EXHIBIT B

LICENSE AMENDMENT REQUEST  
DATED MARCH 21, 1978

This exhibit consists of the following pages revised to incorporate all of the proposed Technical Specification changes:

Figure 3.11.1-Ba

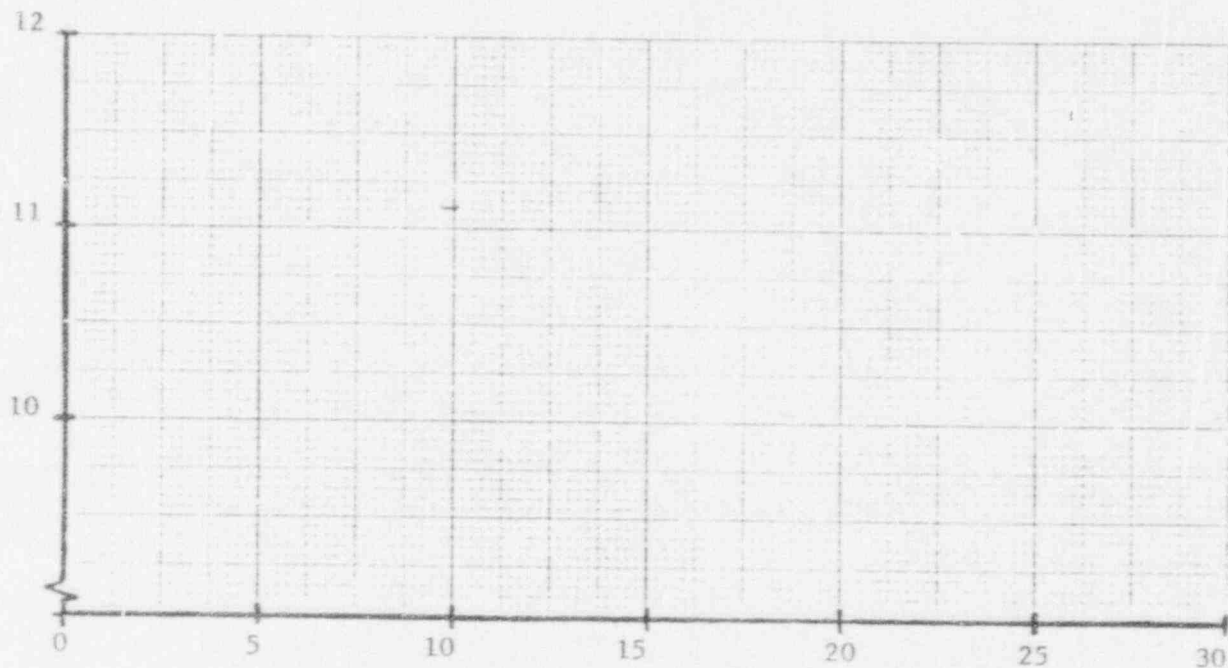
Maximum Average Planar Linear  
Heat Generation Rate Versus  
Planar Average Exposure  
Monticello 8DR282 Fuel

Calculated Results to  
be provided at a later  
date
